Comments on Proposed Rule 40A-8.041 Minimum Flow for Wakulla Spring and Sally Ward Spring

March 8, 2021

Robert E. Deyle, Professor Emeritus, Florida State University

Figure 34: Full Composite Wakulla Spring Discharge Time Series from May 10, 1997, through December 31, 2019

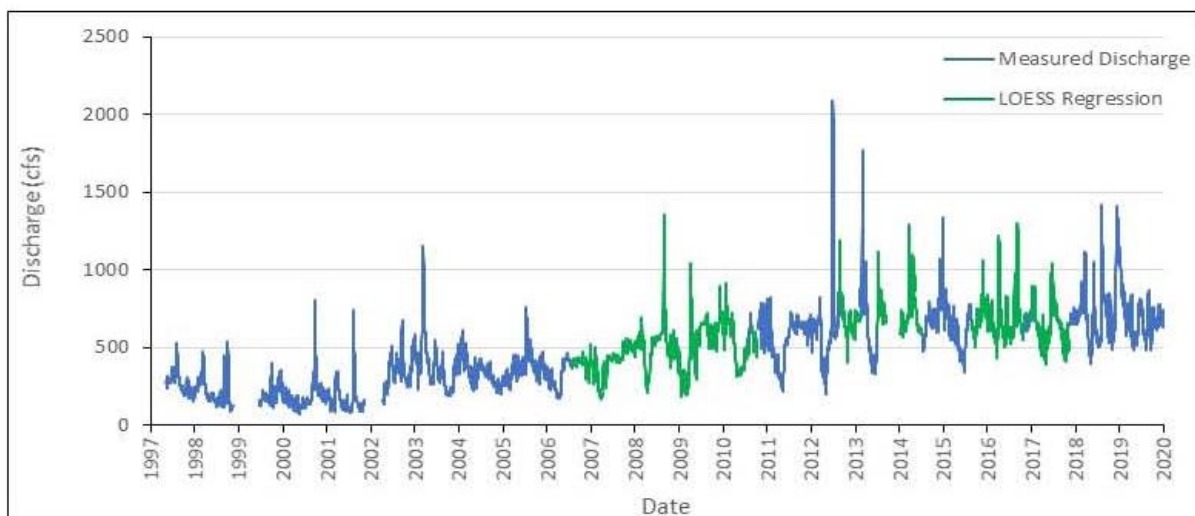
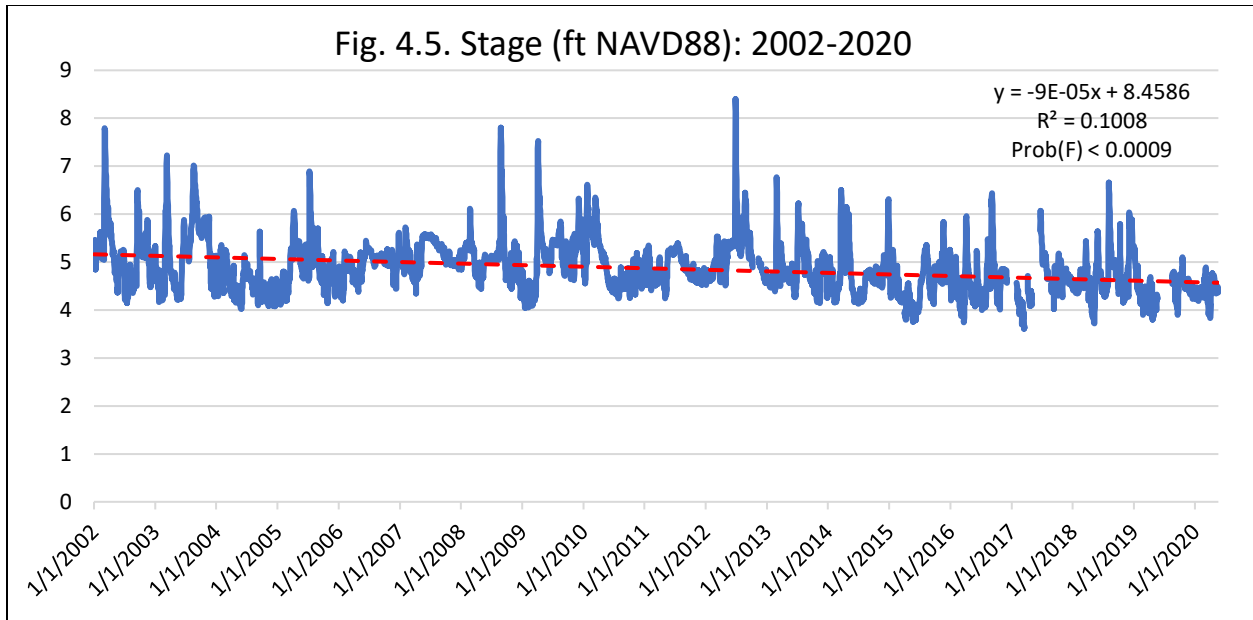
While the Technical Assessment demonstrates that Wakulla Spring discharge has been relatively stable since about 2012, after increasing between 2002 and 2012 (figure 34), my analysis shows that upper river stage measured at the boat tram has exhibited a statistically significant decreasing trend since 2002 (figure 4.5).
